CONVAIR

COMMERCIAL CHANGE PROPOSAL

SPEC NO.: ZD- 22-002

MODEL: (880) 22-1

ANTENNA ARRANGEMENT
Figure 3.17-3
(For Antenna location only)

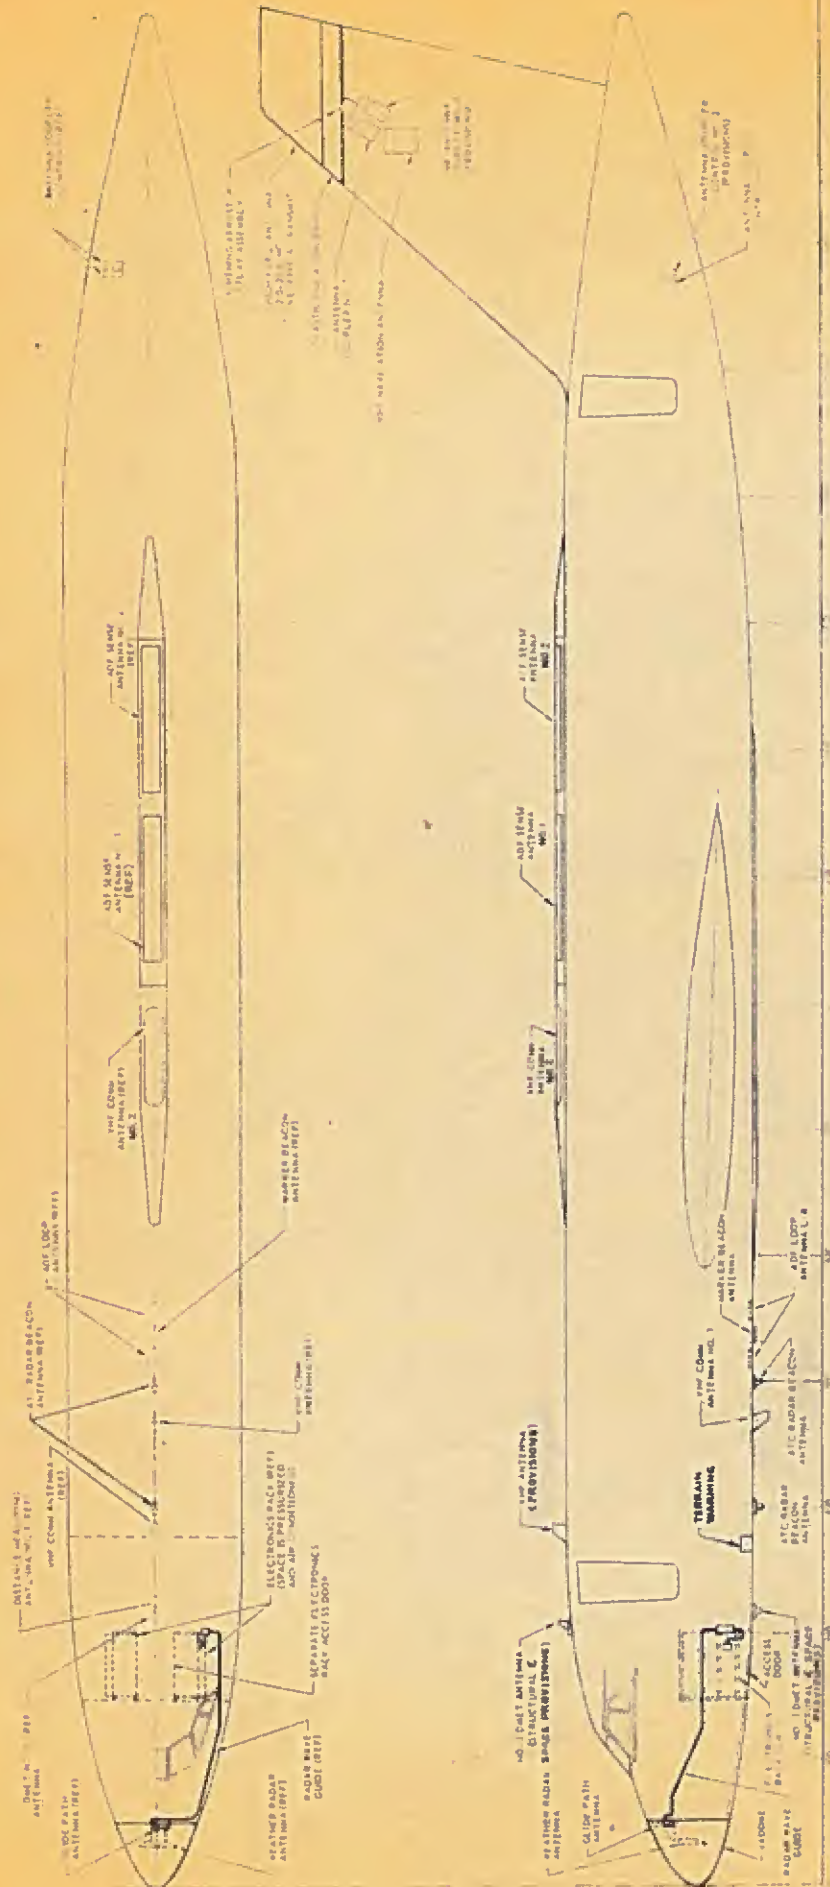
Page 104C, add the following illustration:

"Antenna Arrangement"
